RESPONSES TO CEC COMMENTS ON THE  
MODELING PROTOCOL SUPPLEMENT FOR  
THE HYDROGEN ENERGY CALIFORNIA  
(HECA) PROJECT

Revised Application for Certification (08-AFC-8)

**Technical Area:** Air Quality

**ATTACHMENT 4-1**

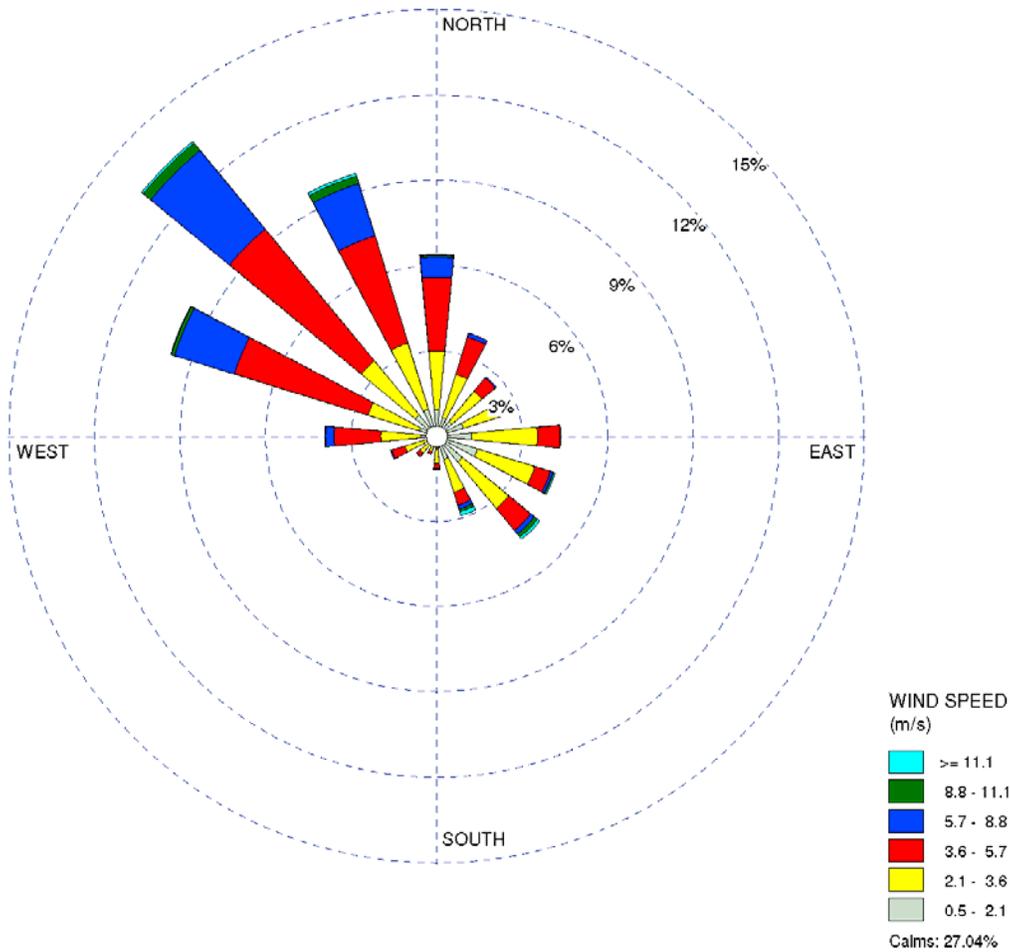
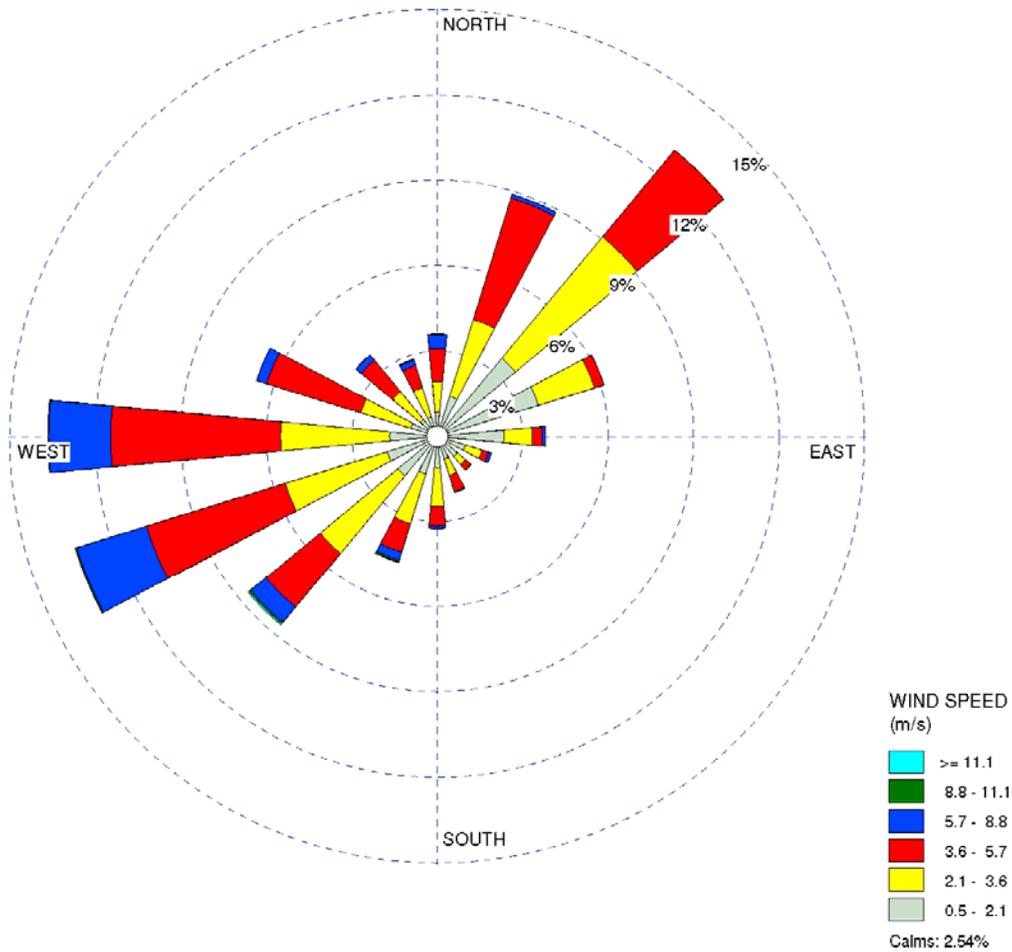
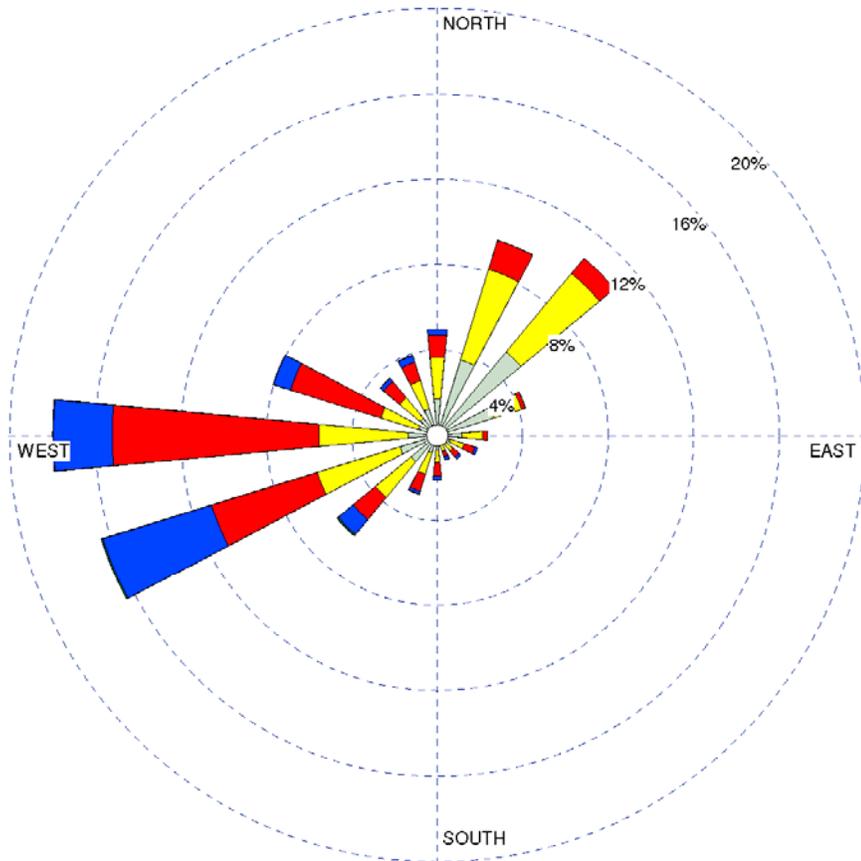
4. ***Page 9 – Meteorological data selection. It is understood given SJVAPCD modeling guidance why the Bakersfield meteorological data was selected for the criteria pollutant modeling analysis, but there is MM5 derived meteorological data from the west side of air basin that could be used for the HRA modeling. Please discuss why this data isn't being used and identify if SJVAPCD was consulted about the use of this data for the HRA and the results of that consultation.***

SJVAPCD was consulted, and they provided meteorological data to be used for all dispersion modeling analyses using the American Meteorological Society/Environmental Protection Agency Regulatory Model (AERMOD), including both Ambient Air Quality Standards and Health Risk Assessment (HRA) modeling. SJVAPCD processed and provided to HECA the data from the most representative meteorological station, the Bakersfield airport, for the five most recent available meteorological years. HRA modeling will use AERMOD and Hotspots Analysis and Reporting Program (HARP) On-Ramp with the same meteorological data set used for the criteria pollutant modeling analyses for consistency with the analyses that will be conducted by SJVAPCD in review of the air permit. SJVAPCD has provided hourly meteorological data that pair in time with the hourly background ozone and nitrogen dioxide data for 2006–2010. This is the most recent 5-year data set available for all parameters needed. HECA will be using these years of data for all modeling analyses.

To determine the most representative meteorological station, SJVAPCD and HECA considered many factors. The HECA Project is situated in a valley at a base elevation of 87 meters. The Bakersfield airport station is 20 miles away and is also situated in the valley, with an elevation of 149 meters. However, sites on the west side of the air basin that use the MM5 data for the basis of the data set are at Missouri Triangle and Fellows, both upslope in the hills west of the HECA Project Site, at base elevations of 268 meters and 472 meters, respectively. Temperatures would generally be cooler in the hills, and wind patterns are not as representative at these stations as at the Bakersfield airport station, which is situated in the valley, as is the HECA Project Site.

Attachment 4-1 presents wind roses for a comparison of wind speed and direction at Bakersfield Meadows Field Airport, Fellows, and Missouri Triangle stations for the most recent 5-year periods at each site. The wind directional patterns differ more in the valley than in the hills; therefore, the most representative meteorological data from the Bakersfield station will be used for the criteria pollutant and HRA modeling.
